METROPOLITAN GOVERNMENT OF NASHVILLE AND DAVIDSON COUNTY

STAFF RECOMMENDATION
515 Acklen Park Drive
April 17, 2013

Application: Demolition—primary building; New construction—infill
District: Richland-West End Addition Neighborhood Conservation Zoning Overlay
Council District: 24
Map and Parcel Number: 10405007500
Applicant: Preston Quirk
Project Lead: Melissa Baldock, melissa.baldock@nashville.gov

Description of Project: Application is to demolish the existing structure that spans two lots at 515 and 517 Acklen Park Drive and construct one duplex on the lot for No. 515. A similar duplex is proposed for No. 517, and will be addressed under a separate application and staff recommendation.

SITE PLAN

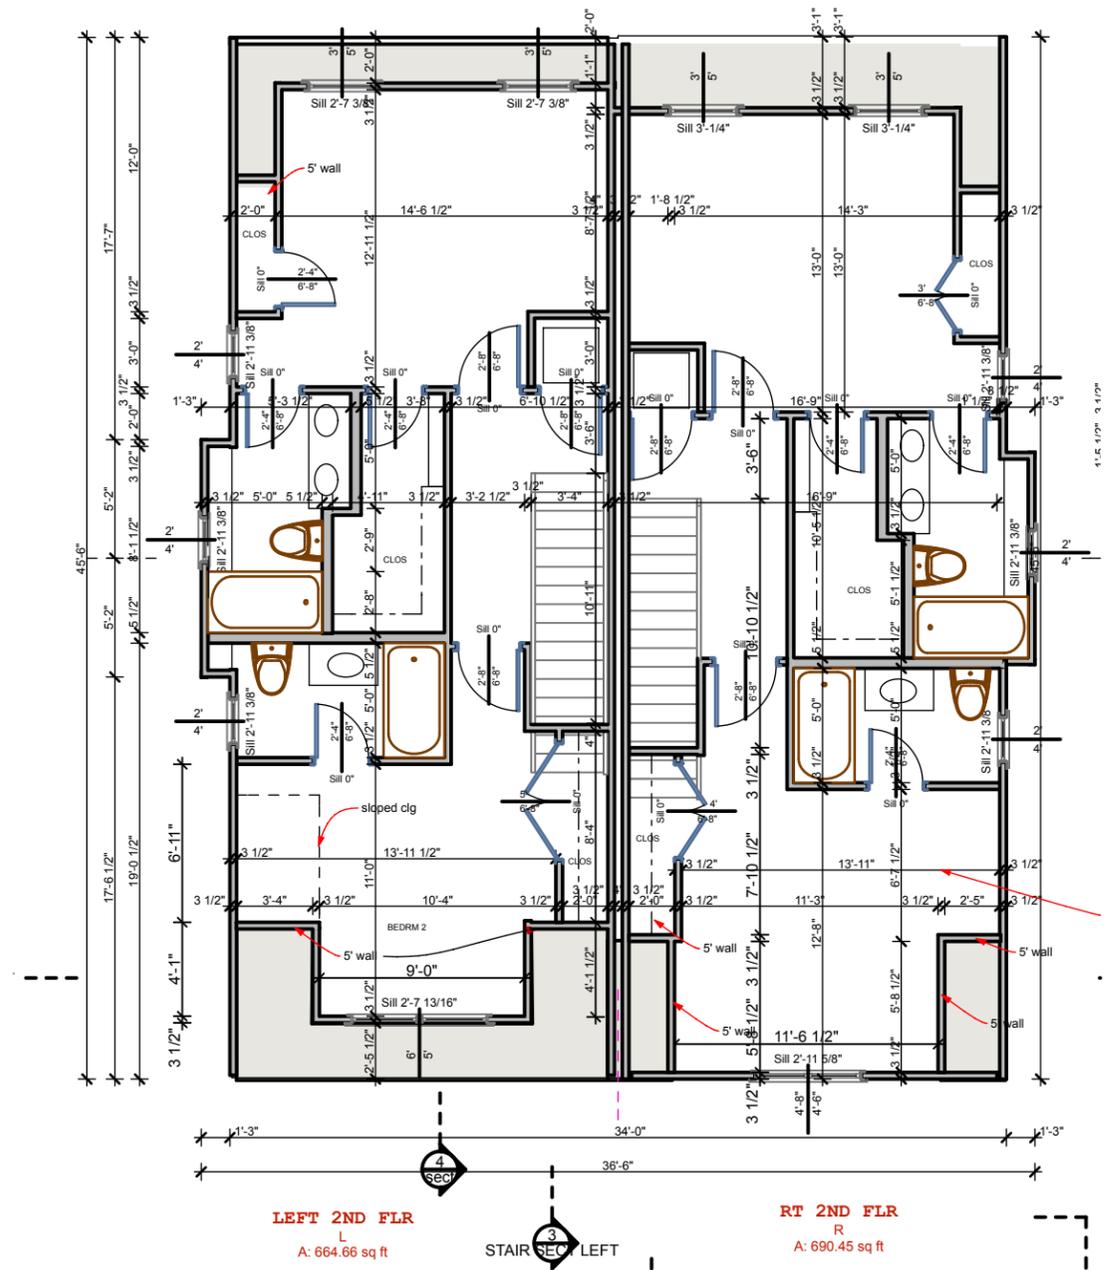
Location and Setback: The proposal meets all bulk zoning setback requirements. The lot for No. 515 is angled at the front, but the house will be situated to be parallel to the rear lot line, which is not angled. Because there is no historic context on this street, the front setback, which ranges from thirty-four feet (34') at its closest point to forty-three feet (43') at its farthest point, is appropriate. The duplex will be shifted slightly on the lot so that it is approximately six feet, four inches (6'4") from the right side property line and approximately eleven feet, four inches (11'4") from the left side property line. Staff finds that the duplex meets Sections II.B.1.c. and II.B.1.h. of the *Richland-West End Addition Neighborhood Conservation Zoning Overlay Handbook and Design Guidelines*.

Appurtenances: The site plans shows two double-width parking pads in the rear of the property, accessed from the alley, which is appropriate. No other appurtenances were indicated on the site plan, and staff asks to review and approve any other appurtenances before they are installed.

ELEVATIONS

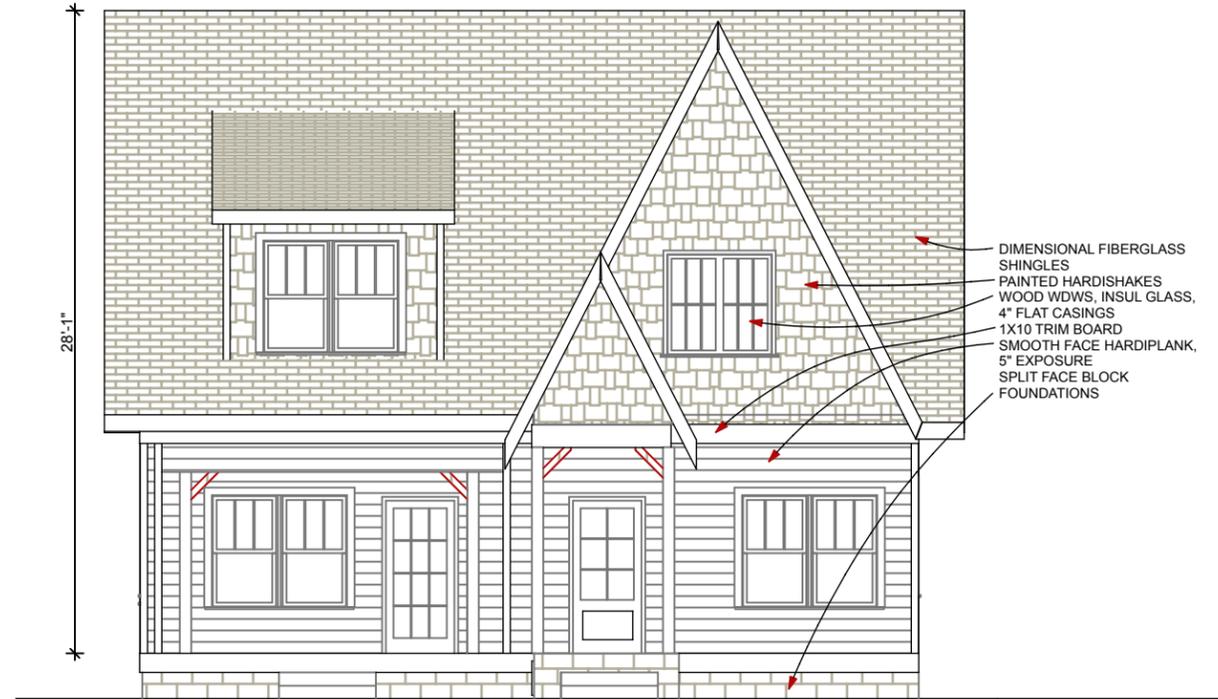
Height & Scale: The proposed structure will be one-and-a-half stories and will have a maximum ridge height of thirty feet, one inch (30'1"), which includes the two foot (2') tall foundation. The house's eave height is approximately eleven feet (11'). The duplex will be thirty-four feet (34') wide and forty-five feet, six inches (45'6") deep. Because the structure is a duplex, there are two entries. The entry on the left will be behind a six foot (6') deep porch. The entry on the right is behind a covered entryway that is four feet (4') deep and six feet, three inches (6'3") wide. Although staff typically asks that porches be six feet (6') deep, staff finds the shallower entryway to be appropriate because it is narrower than a typical porch and will read more as a covered entryway.

Materials: The structure's primary cladding material will be smooth-face cement fiberboard with a five inch (5") reveal. Painted Hardishakes will be used as an accent material on the front gables and on the front dormer. The house's foundation will be split face concrete block, and the roof will be dimensional fiberglass shingles. Staff asks to review the shingle color prior to purchase and installation. The windows will be wood, and the door material was not specified. Staff asks to review all window and door materials and specifications prior to purchase and installation. The porch columns lack a base and a cap, and staff asks that these be added to the columns. The materials for the porch columns, floor, and steps on both the front and rear facades were not specified, and staff asks to review these materials as a condition of approval. If a front porch railing is installed, staff will want to review and approve the design and material of the railing prior to purchase and installation.

Roof: The infill's primary roof form will be a cross-gable. The cross gable at the front and the gable over the entryway will have a steep slope of approximately 24/12. The house's side gable will have a roof slope of 9/12. On the front slope of the house will be a dormer with a shed roof. The dormer is set in two feet (2') from the front wall of the house and more than two feet (2') from the house's sidewall. The rear roof slope also has a shed dormer. Each of the side gable fields has a shed roof bay window that protrudes beyond the wall of the house by one foot, three inches (1'3"). Staff finds the primary structure's roof forms to meet Section II.B.1.e. of the *Richland-West End Addition Neighborhood Conservation Zoning Overlay Handbook and Design Guidelines*.

Proportion and Rhythm of Openings: The primary windows on the duplex are approximately twice as tall as they are wide, and so meet the historic ratio of windows. In addition, the windows on the upper stories are as tall or are shorter than the windows on the primary floor. The two side facades do contain a wall expanse of approximately sixteen feet (16') without a window or door opening. Staff finds this expanse to be appropriate because it occurs on the back half of the house and therefore will be less visible from the street. Staff asks that the applicant ensure that there are four to six inch (4" – 6") mullions in between the house's double windows. With this condition, staff

1. The porch columns have a cap and a base.
2. Staff review and approve the asphalt shingle color, the materials and specifications for all windows and doors, and the materials for the front and rear porchs' columns, steps, and floor.
3. Staff approve the material and design of the porch railing if one is installed.
4. Four to six inch (4"-6") mullions be included in between all double windows.
5. The HVAC and other utilities be located at the rear of the structure, or on a side façade, beyond the midpoint of the house.
6. Staff review any appurtenances not indicated on the submitted plans and elevations.
